# COUNTAX™

## **SERVICE BULLETIN**

**15-08-37**

**MODELS:** MK4 C, B, T, F –SERIES AND ECHO TRACTOR MODELS

Fig. 1 Remove M8 Flange bolts and nuts.

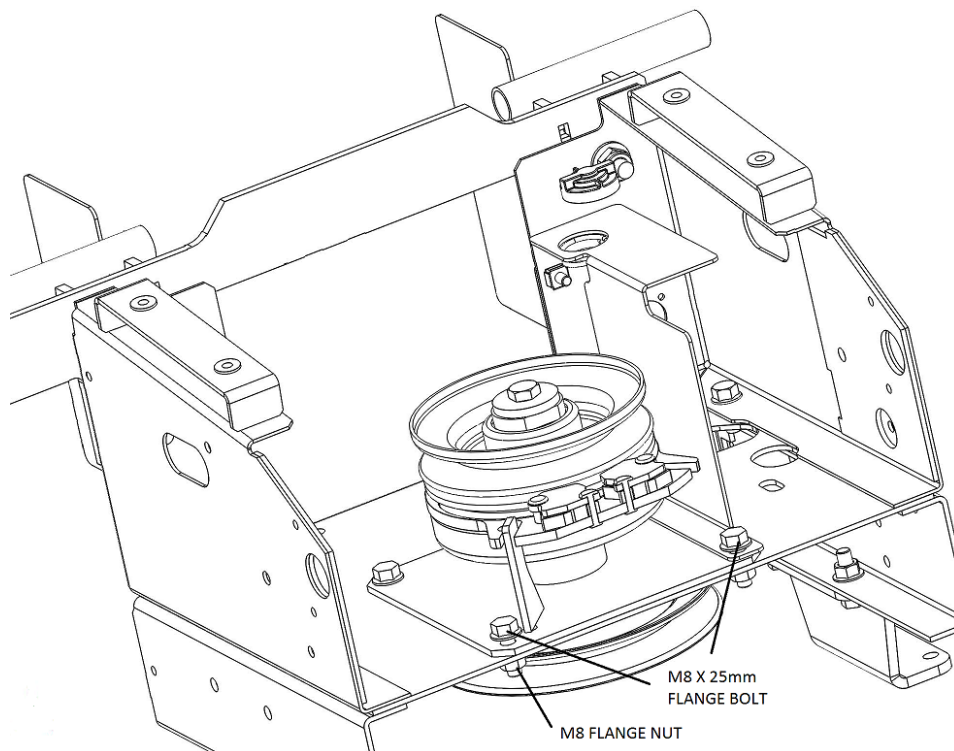
- Please disconnect the battery, disengage the PTO switch and turn off the engine.
- Remove two M8 x 25mm bolts and M8 flange nuts in PTO clutch assembly as shown in Figure 1.
- Assemble the PTO clutch stop bracket(549129800) and M8 x 40 hex bolt/flange nut as shown in Fig.2
- Line up the PTO clutch stop bracket assembly with the existing holes on the Chassis and the Anti-rotation slot in PTO clutch as shown in Figure 3.
- Secure the bracket with existing M8 X25 Flange bolt and M8 Flange nut as shown in Fig. 3.
- Ensure the clutch has both axial and radial free play at minimal level. (refer fig. 4)
- Please reconnect the battery, turn on the Engine and engage the PTO clutch and ensure the clutch is free from rattling noise.
